Revised Final Plan
Attachment 9.12

Structures & Operational Sites - Working at Heights - Appendix B

**Dampier Bunbury
Pipeline**

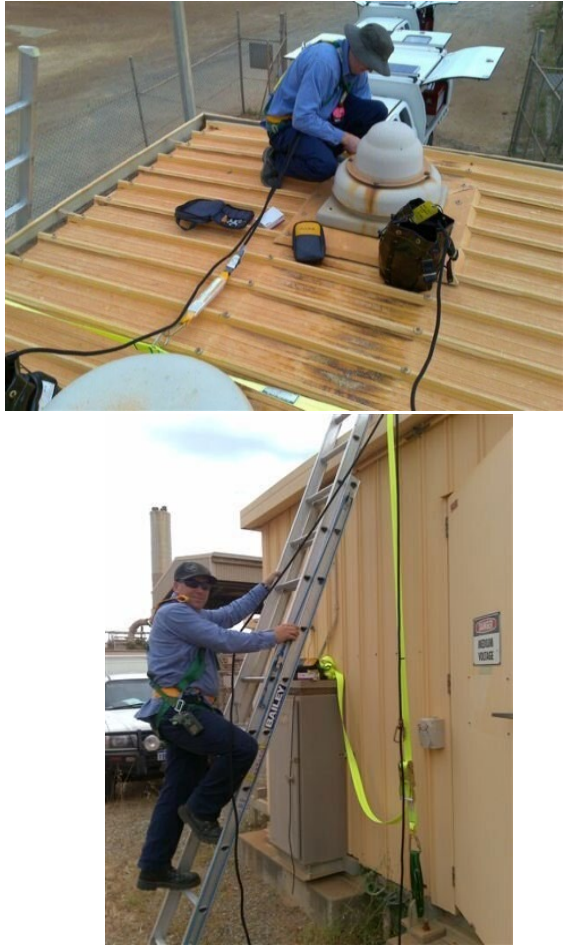
Spur 5 - 2	22/04/2024	Spur 5 - TEG	1) No hi vis (yellow) anti-slip tread installed on the nosing of the stairs. 2) No handrails are installed and therefore the AS requirement (2 or more stairs) is not being met. Note: Non-compliance identified but not action is recommended as minimal risk of a fall from height and low usage. Assessed using surveillance photo. Additional photos requested to confirm accuracy of assessment.	B. Remote	2. Minor	Low	1) Ensure hi vis (yellow) anti-slip tread is installed on the nosing of all stairs (width top step 870mm, bottom step 770mm). 2) No action required.				
Spur 5 - 3	22/04/2024	Spur 5 - Tower	1) Unlike some other Repeater Stations, the ladder at this location can be access from ground level. No gate or means of accessing the ladder on a platform at height to prevent unauthorised access, has been implemented. 2) No fall restraint/arrest system in place for personnel using the ladder. This exposes personnel to a significant fall that would likely result in a fatality or serious injury. 3) The width of the ladder appears it does not meet the AS requirements (375mm to 525mm) and may create a hazard to personnel using the ladder. 4) No hi vis (yellow) anti-slip tread installed on the ladder rungs. They are currently smooth metal rungs. Note: Assessed using surveillance photo. Additional photos requested to confirm	C. Unlikely	4. Major	High	1) Consider installing a lockable gate or similar and signage is provided to prevent unauthorised access. 2) Install a certified fall restraint/arrest system that is suitable for the end users. 3) Replace the ladder with a AS compliant ladder. 4) Install hi vis (yellow) anti-slip tread on the ladder rungs.

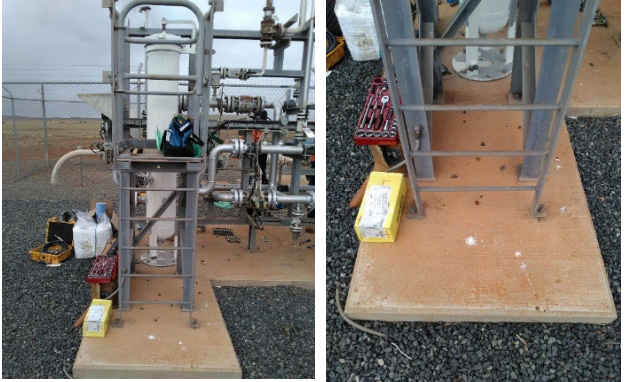
Rockingham Meter Station - 4	5/03/2024	Rockingham Meter Station -Access Platform	<p>1) Ladder rungs are smooth and does not have anti slip tread.</p> <p>2) Ladder is not install on centre of landing. The landing does not meet AS1657 requirements (e.g. actual 580mm vs required 900mm depth).</p>				<p>1) Install hi vis (yellow) anti slip tread onto all ladder rungs.</p> <p>2) Replace the landing.</p>

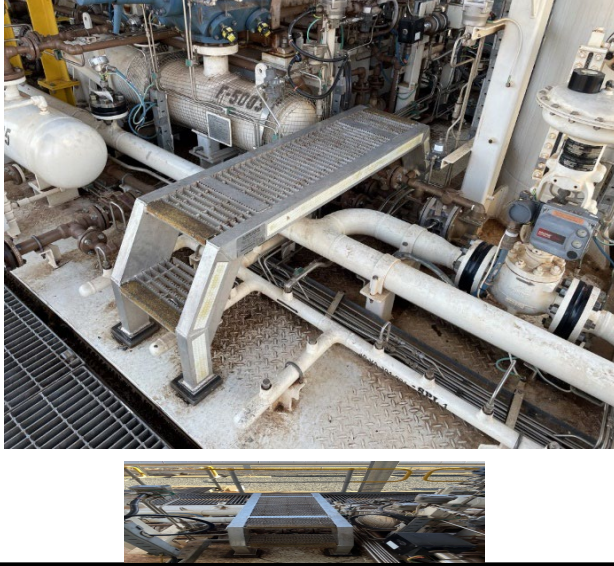
Mondarra Meter Station - 1	5/10/2023	Mondarra Meter Station - Metering Skid	<p>1) Concrete slab used for stairs but do not meet AS requirements.</p> <p>2) Landing on one side does not meet AS requirements. The other side has blue metal as landing which can be slippery.</p> <p>3) No hi vis nosing on stairs and edge of platform.</p> <p>Note: Height of fall 600mm.</p>	C. Unlikely	3. Severe	Medium	<p>1) Redesign the stairs to meet AS requirements (e.g. implement a 3rd step). If 2 or more steps are in place, then handrails are required.</p> <p>2) Landing to be poured to suit new stair design and AS requirements.</p> <p>3) Install hi vis (yellow) non-slip tread installed on the nosing of all stairs.</p>	 			
Mondarra Meter Station - 2	5/10/2023	Mondarra Meter Station - Metering Skid - Platform Landed on Skid	<p>1) No hi vis nosing on stairs and edge of platform.</p> <p>2) No edge protection on the platform. Depending on the side, there is potential for a fall through the pipework onto ground below or grid mesh deck.</p>	C. Unlikely	3. Severe	Medium	<p>1) Install hi vis (yellow) non-slip tread installed on the nosing of all stairs.</p> <p>2) Install edge protection on platform.</p>

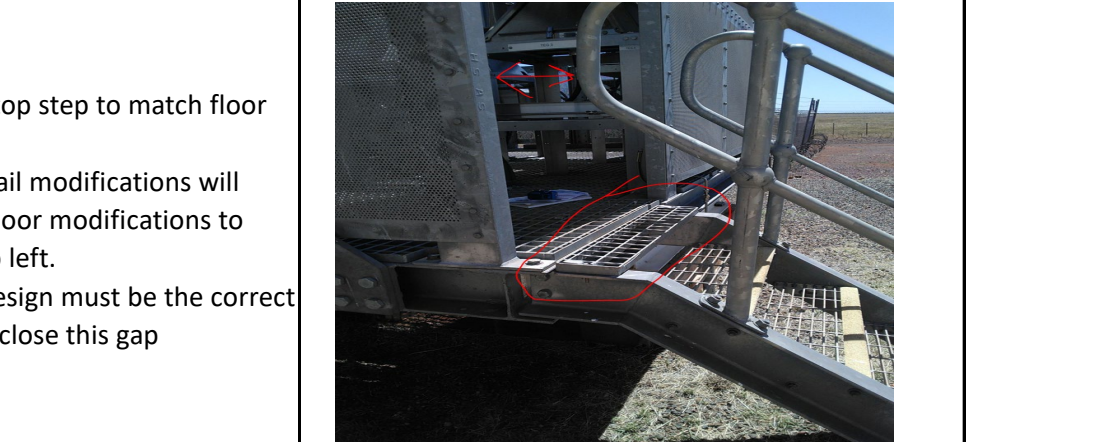
Dampier Facilities - 4	29/08/2023	Platforms for HV220 and HV241	1) No hi vis (yellow) tread installed onto each ladder rung (450mm).	C. Unlikely	2. Minor	Low	1) Hi vis (yellow) non-slip tread to be installed on the ladder rungs.

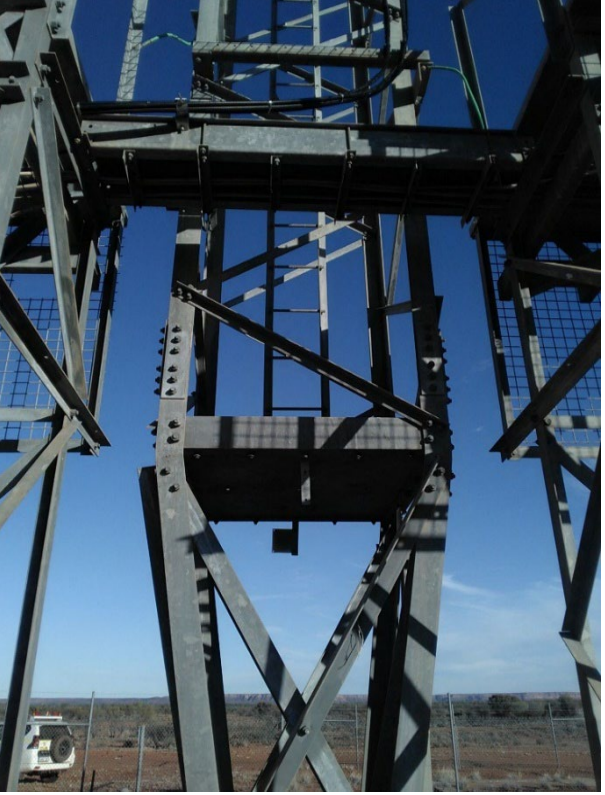
Maitland Estate Meter Station - 1	29/08/2023	Access Ladder / Platform For Riser	<p>1) The depth landing (e.g. 460mm) does not meet AS requirement (e.g. 600mm).</p> <p>2) No hi vis (yellow) anti-slip tread installed on the ladder rungs.</p>	C. Unlikely	2. Minor	Low	<p>1) Pour a new landing.</p> <p>2) Ensure hi vis (yellow) anti-slip tread is installed on the rungs.</p>

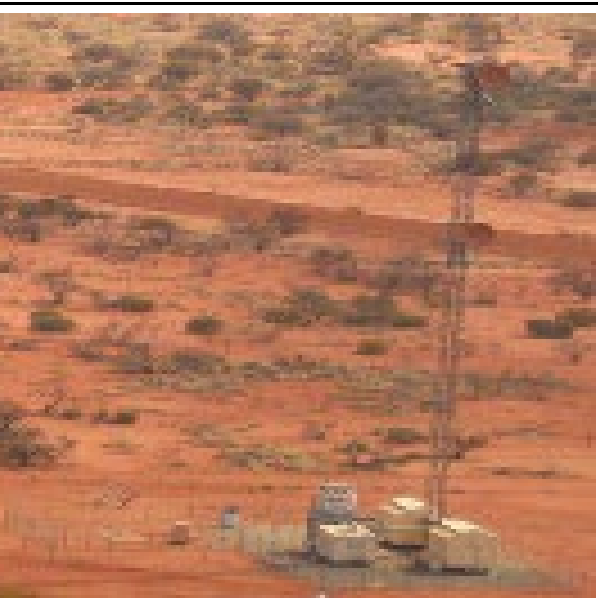
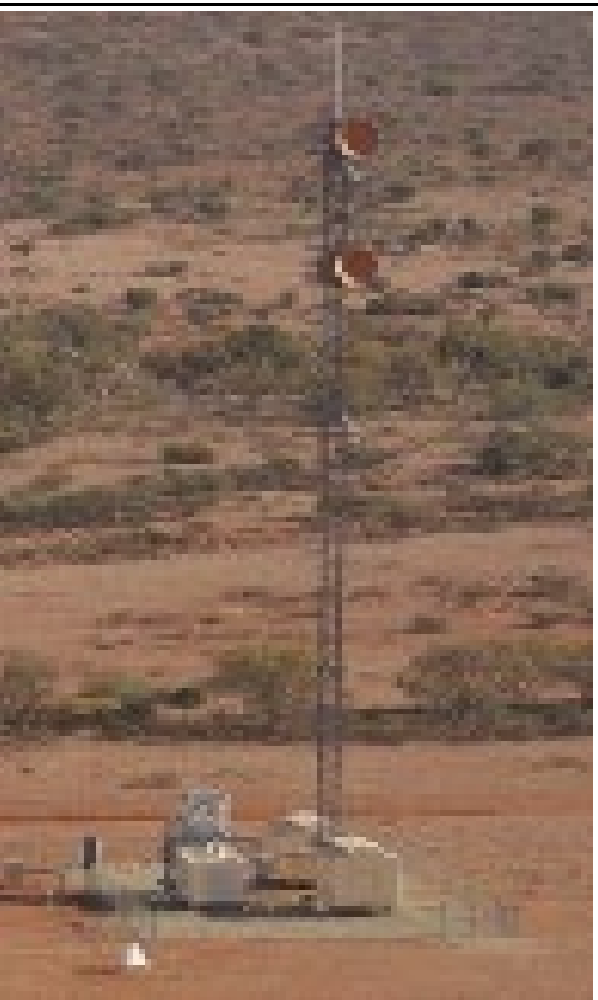
Pluto Interconnect Compressor / Metering Station - 5	11/08/2023	Multiple Hand Valves	1) Existing landings are off centre and insufficient size to position a platform ladder or safety step, to access the hand valves. This creates the risk off a fall.	C. Unlikely	3. Severe	Medium	Option A: Install concrete landing for platform ladder to be set up on. Option B: Install a purpose built platform and access stairs or ladder that is AS compliant.

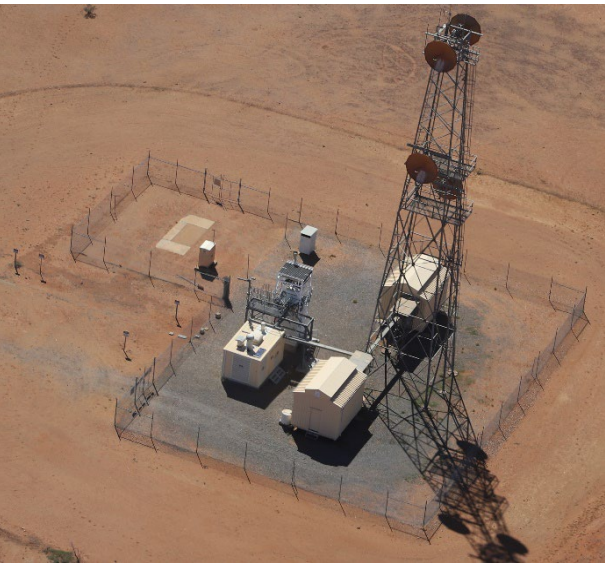
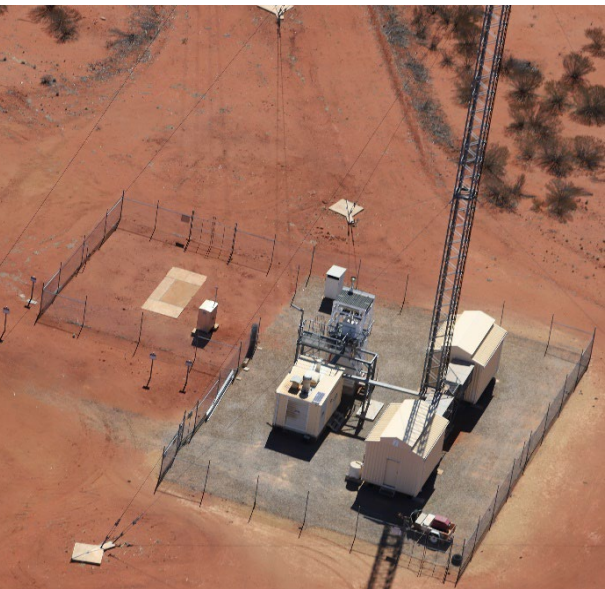
AGR Meter Station - 2	25/07/2023	Mercaptain Tank (Style 2)	1) The Step Up from the ground to the landing / work platform (grid mesh) is 370mm and therefore the AS requirement (300-450mm) requires a minimum of 1 step be provided.	B. Remote	3. Severe	Medium	1) Install a intermediate step between the ground and landing / work platform to meet AS requirements. 2) Ensure hi vis (yellow) anti-slip				
AGR Meter Station - 3	25/07/2023	Access Stairs from Side Gate to Mercaptain Vessels Bund	1) The depth landing (e.g. 300mm) does not meet AS requirement (e.g. 600mm). The edge of the landing (blue metal side) also has a curved edge posing an additional risk of a rolled ankle. 2) No hi vis (yellow) anti-slip tread installed on the nosing of the stairs.	C. Unlikely	2. Minor	Low	1) Pour a new landing. 2) Ensure hi vis (yellow) anti-slip tread is installed on the nosing of stairs.

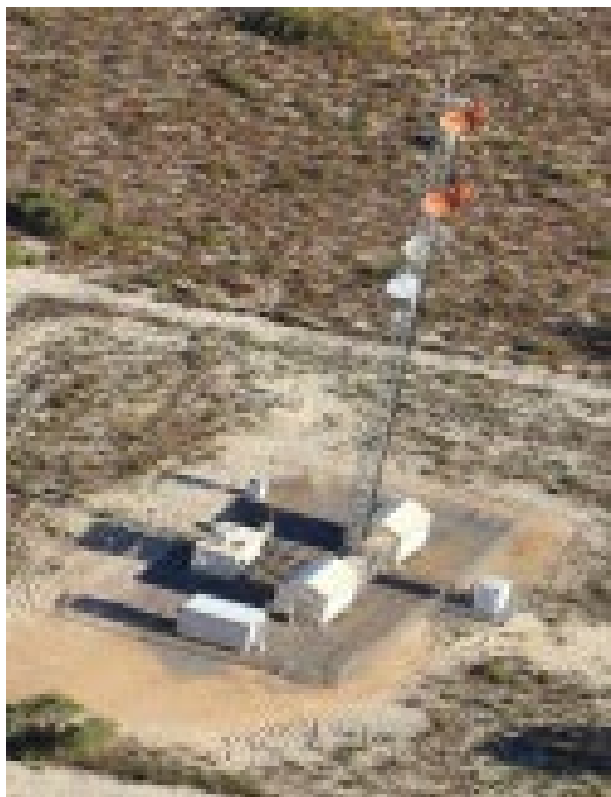
Mandurah Gate Meter Station - 1	13/04/2023	Pav Hut	1) The step up (riser) does not meet the AS requirements (130-225mm).			Low	1.1) Implement a interim step to assist with access and egress. 1.2) Modify the landing to accommodate the new step.

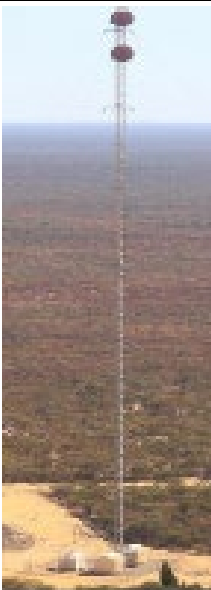
R025-5	22/05/2023	Repeater Station 25 - Larger Communications Tower	<p>1) Unlike some other Repeater Stations, the ladder at this location can be access from ground level. No gate or means of accessing the ladder on a platform at height to prevent unauthorised access, has been implemented.</p> <p>2) The Step Up to access the first ladder rung (520mm) exceeds the AS requirements (≈150mm).</p> <p>3) No fall restraint/arrest system in place for personnel using the ladder. This exposes personnel to a significant fall that would likely result in a fatality or serious injury.</p> <p>4) No hi vis (yellow) anti-slip tread installed on the ladder rungs. They are currently smooth metal rungs.</p> <p>Note: Discuss findings and actions with Dane.</p>	C. Unlikely	4. Major	High	<p>1) Consider installing a lockable gate or similar and signage is provided to prevent unauthorised access.</p> <p>2) Extend the ladder to the landing.</p> <p>3) Install a certified fall restraint/arrest system that is suitable for the end users.</p> <p>4) Install hi vis (yellow) anti-slip tread on the ladder rungs.</p>

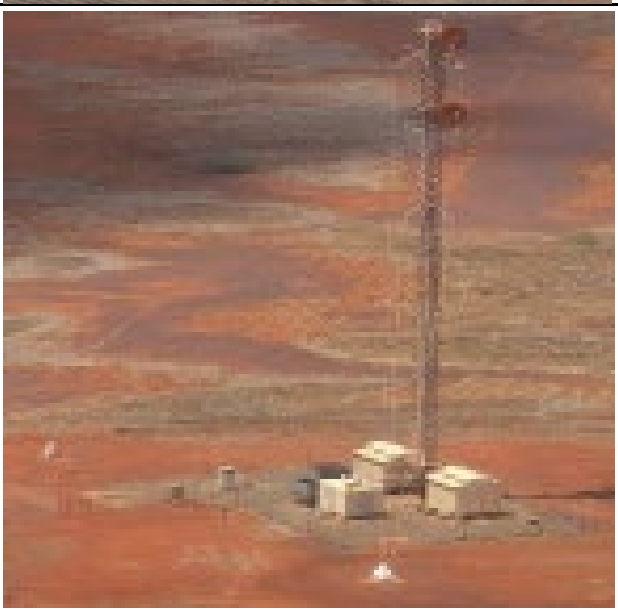
R004-4	4/04/2024	Repeater Station 4 - Communications Tower	<p>1) No access platform provided for ease of access to the ladder. Note: This may have not be provided for the purpose of preventing unauthorised access.</p>	C. Unlikely	3. Severe	High	<p>1) Install a access stairs/ladder and platform to enable access to the ladder. Ensure a lockable gate or similar and signage is provided to prevent unauthorised access.</p> <p>2) Install a certified fall restraint/arrest system that is suitable for the end users.</p>					
R010-7	4/04/2024	Repeater Station 10 - Communications Tower	<p>Assessed using surveillance photo. Site visit required to obtain additional photos and measurements.</p> <p>1) No access platform provided for ease of access to the ladder. Note: This may have not be provided for the purpose of preventing unauthorised access.</p> <p>2) No fall restraint/arrest system in place for personnel using the ladder. This exposes personnel to a significant fall that would likely result in a fatality or serious injury.</p> <p>3) No ladder enclosure has been installed for the ladder to meet AS requirements (where a fall of more than 6m).</p>	C. Unlikely	3. Severe	High	<p>1) Install a access stairs/ladder and platform to enable access to the ladder. Ensure a lockable gate or similar and signage is provided to prevent unauthorised access.</p> <p>2) Install a certified fall restraint/arrest system that is suitable for the end users.</p> <p>3) Assess if the installation a side screen, ladder cage or other type of enclosure to prevent a sideways fall from the ladder, if practical for the end users.</p>

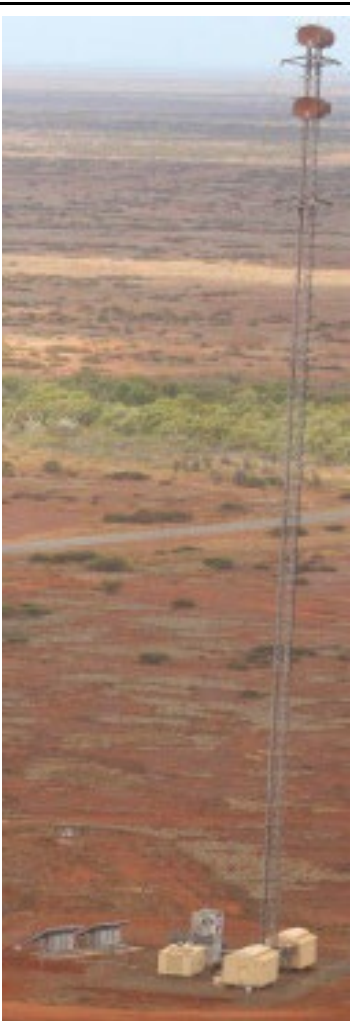
R015-5	4/04/2024	Repeater Station 15 - Communications Tower	<p>Assessed using surveillance photo. Site visit required to obtain additional photos and measurements.</p> <p>1) No access platform provided for ease of access to the ladder. Note: This may have not be provided for the purpose of preventing unauthorised access.</p> <p>2) No fall restraint/arrest system in place for personnel using the ladder. This exposes personnel to a significant fall that would likely result in a fatality or serious injury.</p> <p>3) No ladder enclosure has been installed for the ladder to meet AS requirements (where a fall of more than 6m).</p> <p>4) No hi vis (yellow) anti-slip tread installed on the ladder rungs.</p> <p>Findings on hold pending discussion with Dane. Refer to comments.</p>	C. Unlikely	3. Severe	High	<p>1) Install a access stairs/ladder and platform to enable access to the ladder. Ensure a lockable gate or similar and signage is provided to prevent unauthorised access.</p> <p>2) Install a certified fall restraint/arrest system that is suitable for the end users.</p> <p>3) Assess if the installation a side screen, ladder cage or other type of enclosure to prevent a sideways fall from the ladder, if practical for the end users.</p> <p>4) Install hi vis (yellow) anti-slip tread on the ladder rungs.</p>

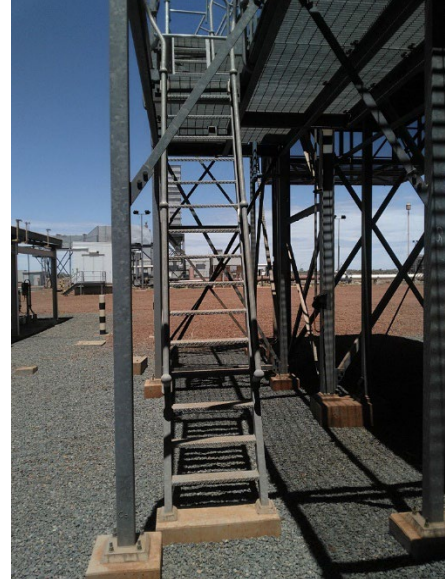
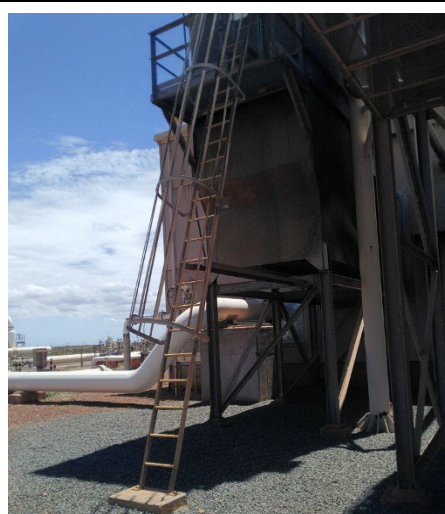
R007-7	22/04/2024	Repeater Station 7 - Communications Tower	<p>Assessed using surveillance photo. Site visit required to obtain additional photos and measurements.</p> <p>1) No access platform provided for ease of access to the ladder. Note: This may have not be provided for the purpose of preventing unauthorised access.</p> <p>2) No fall restraint/arrest system in place for personnel using the ladder. This exposes personnel to a significant fall that would likely result in a fatality or serious injury.</p> <p>3) No ladder enclosure has been installed for the ladder to meet AS requirements (where a fall of more than 6m).</p> <p>4) No hi vis (yellow) anti-slip tread installed on the ladder rungs.</p> <p>Findings on hold pending discussion with Dane. Refer to comments.</p>	C. Unlikely	3. Severe	High	<p>1) Install a access stairs/ladder and platform to enable access to the ladder. Ensure a lockable gate or similar and signage is provided to prevent unauthorised access.</p> <p>2) Install a certified fall restraint/arrest system that is suitable for the end users.</p> <p>3) Assess if the installation a side screen, ladder cage or other type of enclosure to prevent a sideways fall from the ladder, if practical for the end users.</p> <p>4) Install hi vis (yellow) anti-slip tread on the ladder rungs.</p>

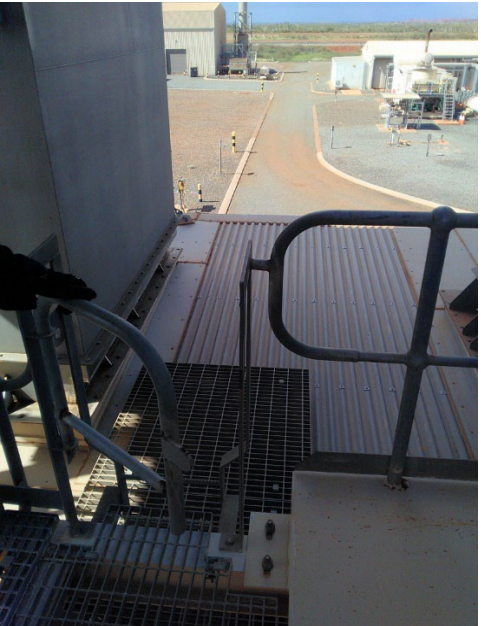
CS01-4	22/02/2023	GEA Fuel Gas Skid	1) Step up / down from grid mesh platform is 450mm and the current design is not compliant with AS 1657 (300-450mm requires a minimum of 1 step). 4 locations of this identified. 2) No hi vis (yellow) strip on the nosing (ends) of the grid mesh platform. 4 locations of this identified.	C. Unlikely	2. Minor	Low	1) Install a step between the landing and grid mesh platform to provide safe access at each location. 2) Install hi vis (yellow) non-slip strip on the nosing of each grid mesh platform (4 locations) as well as stairs installed under Action 1.					
CS01-5	22/02/2023	ACS Lube Oil Cooler	1) Two ladders have landings that does not meet the AS1657 requirements. 2) Two ladders are currently installed on top of concrete steps due to being the incorrect size.	C. Unlikely	3. Severe	Medium	1) Pour a new landing for each ladder. 2) Replace both ladders with the correct size, to ensure it runs from the landing to the platform.

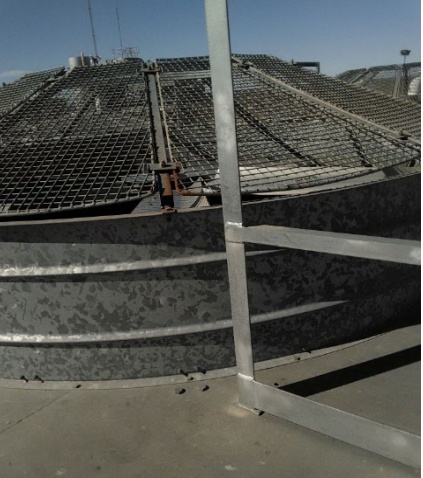
CS03-22	21/04/2023	GEA 1 and 2 - Fuel Gas Skid	1) The step up (370mm) from the ground to the grid mesh platform exceeds AS requirements (130-225mm).	C. Unlikely	2. Minor	Low	1) Install a step between the landing and grid mesh platform to provide safe access at the four access points.					
CS03-23	21/04/2023	Desiccant Dryers x 2	1) The landing (280mm) does not meet AS requirement of 600mm (Depth). 2) No hi vis (yellow) tread installed on the nosing of the platform. 3) Cable tray adjacent to step ups is a trip hazard and the hi vis tape has faded.	B. Remote	2. Minor	Low	1) Remove old landing and pour a new landing. 2) Install hi vis (yellow) tread onto the nosing of the two access points. 3.1) Relocate the cable tray to eliminate the trip hazard if practically possible. 3.2) If the cable tray can not be relocated then apply new hi vis tape.
